BERTHA MINERAL DIVISION	
THE NEW JERSEY ZINC COMPANY	
DATE 6-7-70	SCALE 1" = 30'
11-25-84 STOPE	
DR. POD	TR. POD
CHARGE

7GB-3887

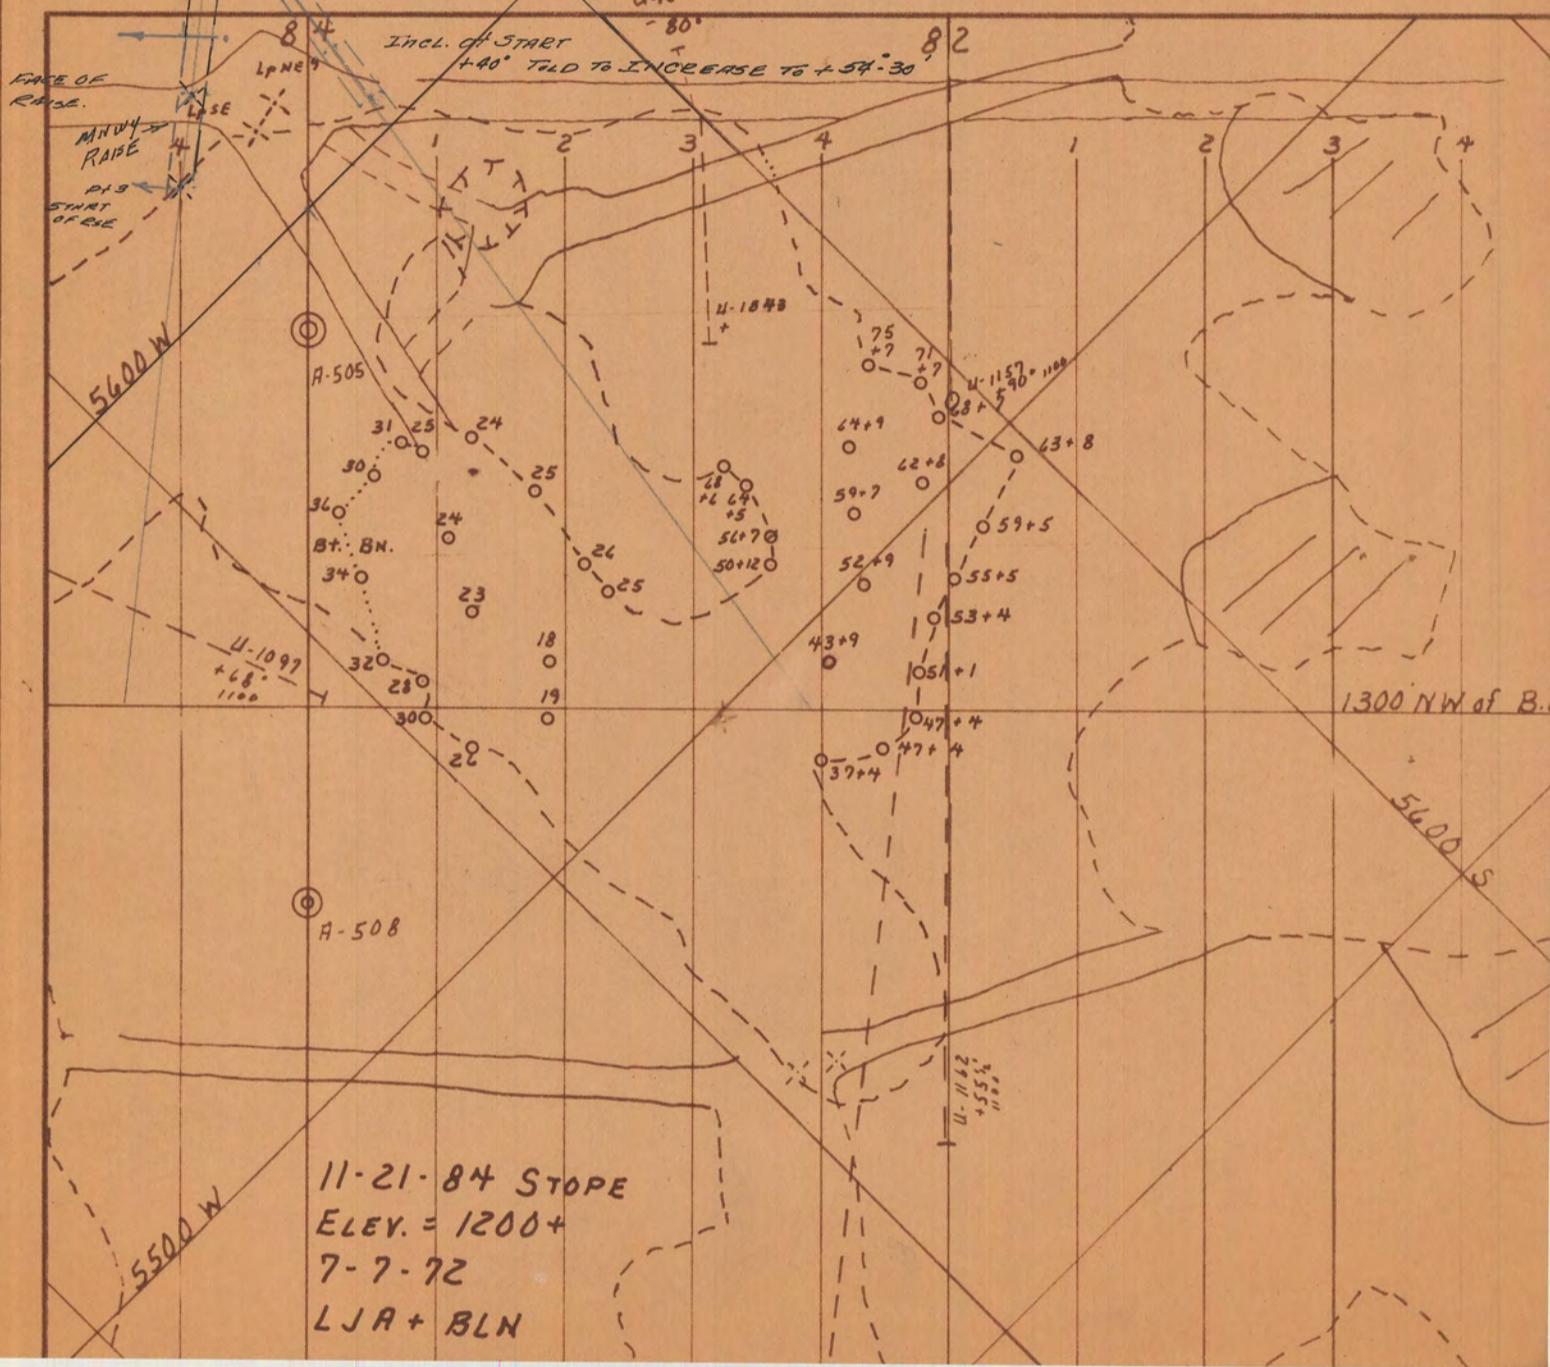
OBSOLETE
WAS NOT DRIVEN
SEE 7GB-3909

SEE CHANGE
of PROPOSAL
FLB

Note: Will turn last sl end. right.
 Proposed BRG.
 11-27 1/2 W.

PROPOSED N-76 1/2 W TOLD TO PULL BACK TO PROPOSED BRG.
 STRATE N-38 W U-1844

Incl. of START
 +40' TOLD TO INCREASE TO +57.30
